Fast-track Approvals Act 2024
of the Bendigo-Ophir Gold Project

STATEMENT OF MATT SOLE ON BEHALF OF SUSTAINABLE TARRAS

Dated 20 August 2026

1. My name is Matt Sole. I provided a statement on behalf of Sustainable Tarras Inc in relation to heritage as relevant to Matakanaui Gold Limited's (MGL) application in March 2026. My qualifications and experience were set out in that statement.
2. The purpose of this statement is to respond to MGL's new information in response to RFI 10 – Heritage.

Bendigo Sanctuary site shown dissecting the current Kohinoor alluvial workings polygon G41/256 and proposed extension to incorporate the full extent of alluvial workings and water races — Kopuwai Archaeology.

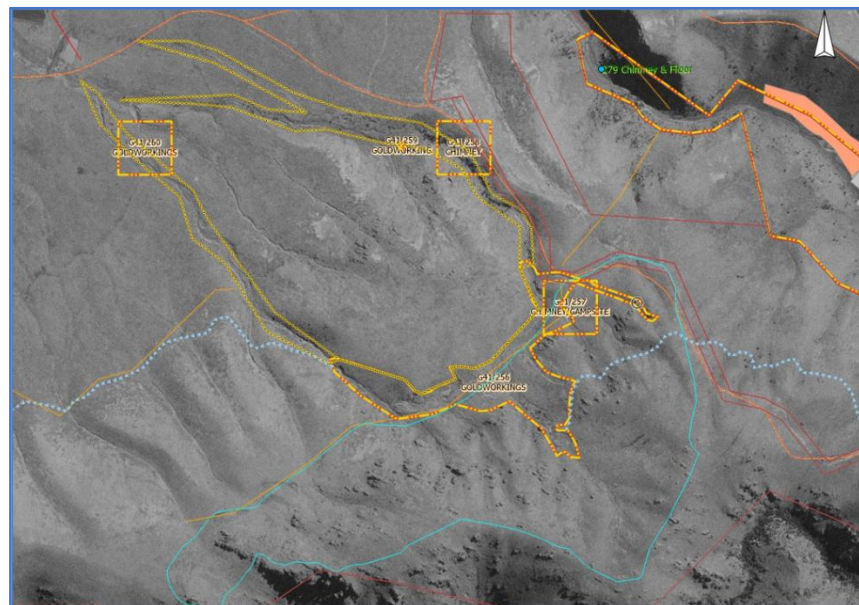
15. The predator-proof fence line dissects the recorded earlier Kohinoor Syndicate alluvial mining workings. If the BOGP is consented, these workings will be the only intact alluvial gold workings remaining in the Rise and Shine and Shepherds Creek area.
16. My assessment indicates that the current site record G41/256 is incomplete. It should be enlarged to incorporate the connecting water race and the downstream alluvial gully workings below G41/256, including recorded chimney hut site G41/258 and gold workings G41/259 and G41/260, as shown in the diagram below.
